General Electric Company
175 Curtin Avenue, San Jose, CA 95125

Docket No. STN 52-001

Subject: Submittal Supporting Accelerated ABWR Review Schedule - **DFSER Chapter 8 Responses**

DFSER CHAPTER 8 ISSUES & GE RESPONSES
.DO FSESTAT .REPORT FORM FCRMemo

Figure 8.3-1
(Sheet 3 of 3)

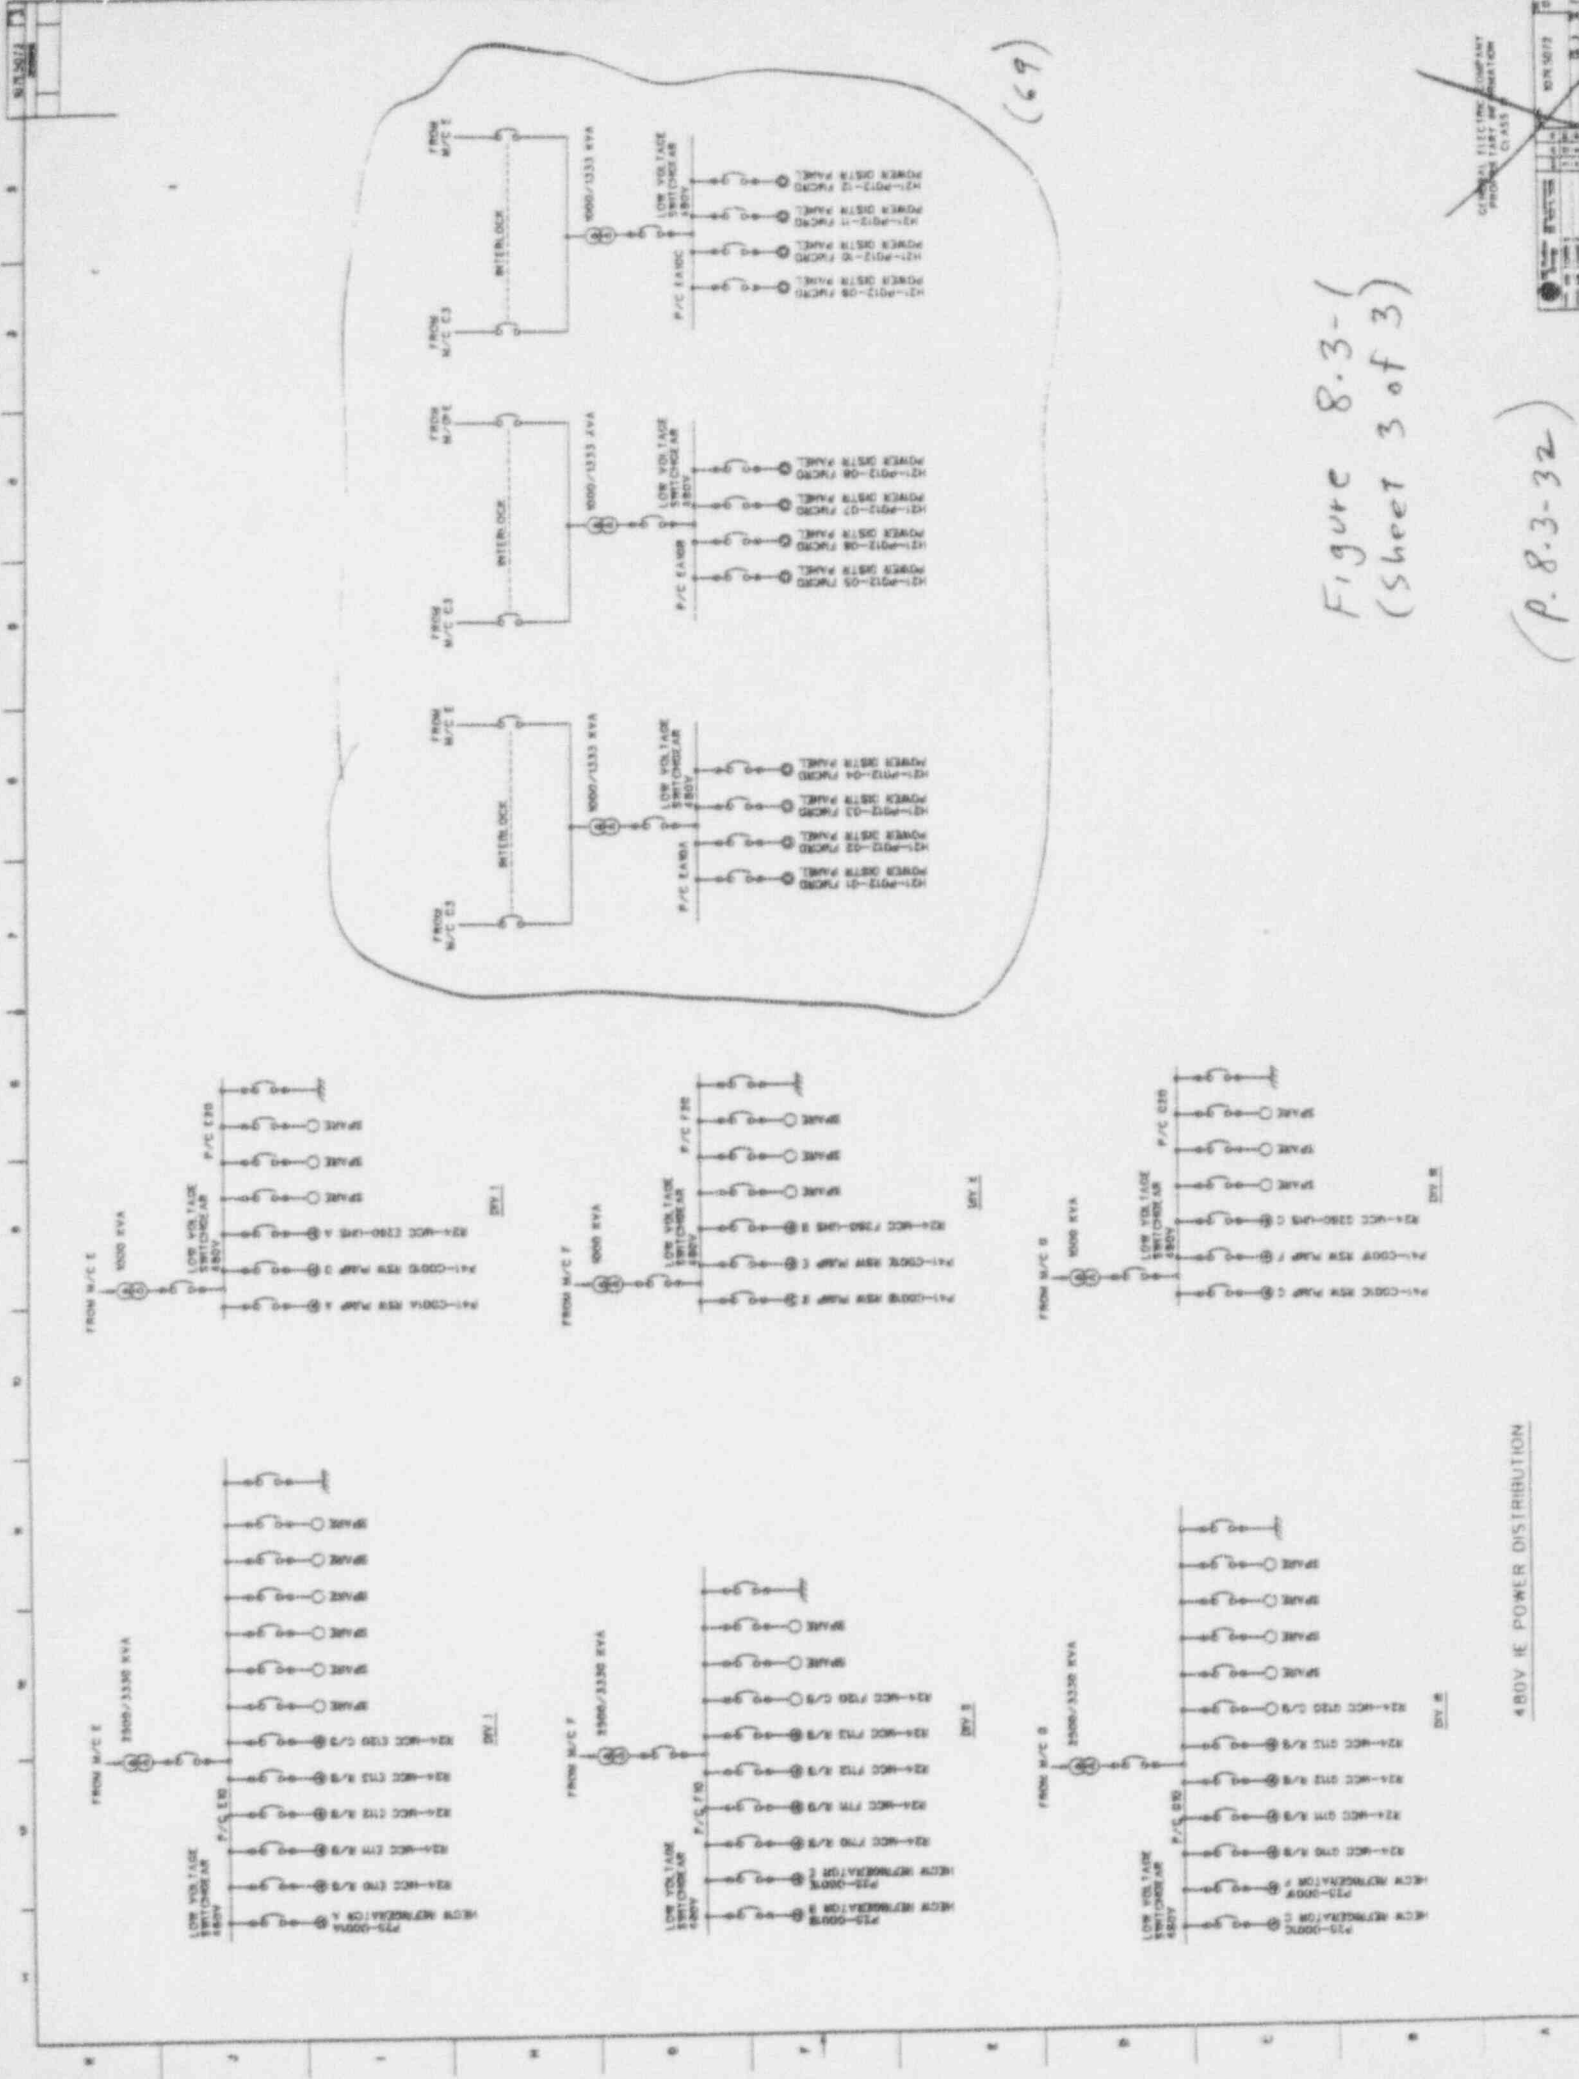
8.3-1	CONF	33	Although considered closed per the February meetings, the staff made a subsequent phone call (3-23-93) to request the transfer switches identified in 8.3.1.1.1, page 8.3-3, be designated as "Class 1E Associated" per our February meeting agreements.	GE responded during the call, that this was being done already in association with the March markup submittal. The specific addition was made in association with DFSER confirmatory item 8.3.3.6-1 (Ref. 69 CONF). The last paragraph on page 8.3-3 has been modified as follows:
				"Power is supplied to each FMCRD load group from either the Division 1 Class 1E bus or the non-Class 1E PIP bus through a pair of interlocked transfer switches located between the power sources and the 6.9 kV/480V transformer feeding the FMCRD MCC. These transfer switches are classified as Class 1E associated, and are treated as Class 1E."
				For clarification, the following sentence was added at the end of the third-to-last paragraph of 8.3.3.6-1 (top of page 8.3-4):

"The design minimizes the probability of a single failure affecting more than one FMCRD group by providing three independent Class 1E feeds (one for each group) directly from the diesel generator backed 6.9 kV bus (see sheet 3 of Figure 8.3-1)."
